# LINDSTRAND BALLOONS LTD

## SERVICE BULLETIN No 6

### ISSUE 1 – DATED 24-8-99

- Title: BURNER VALVE REPAIR
- Classification: Recommended
- Applicability: **All** Jetstream Series 2 Double, Triple and Quad Burners identified by the following part numbers:

FIG 2. JETSTREAM SERIES 2 BURNER SQUEEZE ACTION MODE

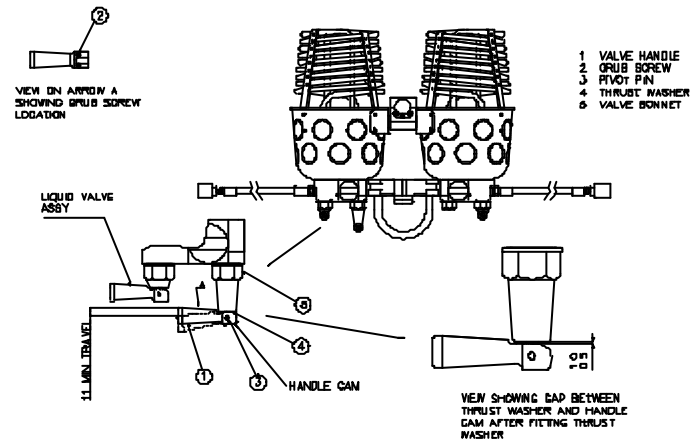
- 3 If the valve handle travel is less than the minimum specified on figures 1 and 2, then the plastic thrust washer (items 4 and 13, figs 1 and 2 respectively) must be replaced as described in the Recovery Action section below.

- 10 Select the new thrust washer from the two supplied to give a clearance between the valve handle cam and the plastic thrust washer of between 0.5mm and 1mm (see figure 2). Note the thrust washer thicknesses as follows:

Thrust washer type BU-008-A-050-A	2.5mm thick
Thrust washer type BU-008-A-050-F	2.0mm thick
- 11 Align the holes in the handle cam with the hole in the valve spindle and replace the pivot pin.
- 12 Fit a new circlip to the pivot pin using a pair of external circlip pliers.
- 13 Using a set of feeler gauges, check that the clearance between the valve handle cam and the thrust washer is between 0.5mm and 1mm as shown on figure 2.
- 14 Place the lower and upper valve posts in position and fit the handle tube.
